A. E. Co. TYPE 101 DIRECTOR
OPERATION

1.01 This Addendum is issued to make changes in Section 240-205-105, Issue 2, in the General System Practices. Using ink or red pencil, make the changes as indicated in Part 2. In the margin adjacent to these changes, write "See Addendum." This addendum should then be filed ahead of Section 240-205-105.

ADDENDUM 240-205-105
ISSUE 1

Figure 4. Translator Interconnections.

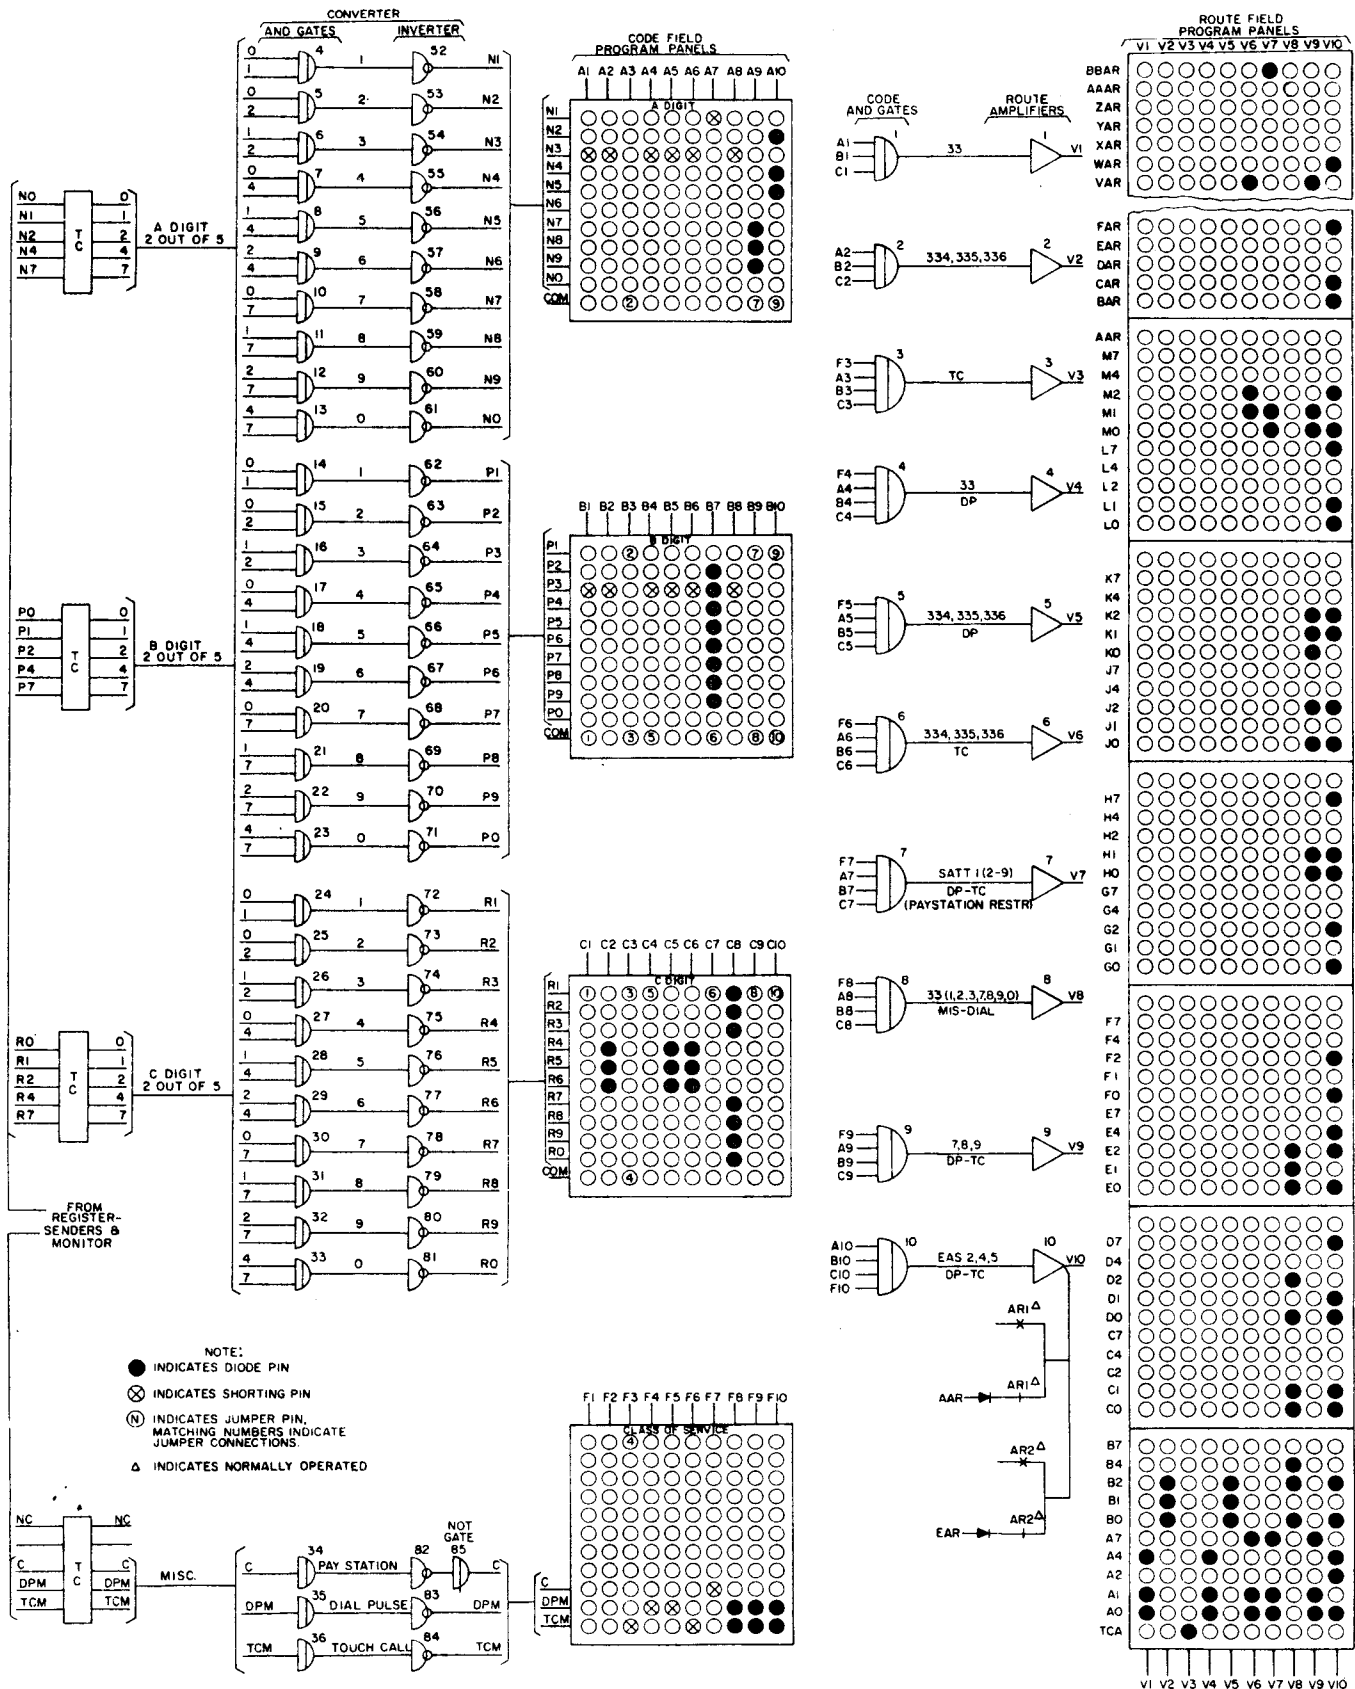
2.01 Cross out Figure 4. The new Figure 4 changes the positions of route diode pins

V7/ZAR and V9/WAR to V7/BB-AR and V9/VAR, respectively. Designation, NOT GATE, is also changed to read NOT GATE 85.
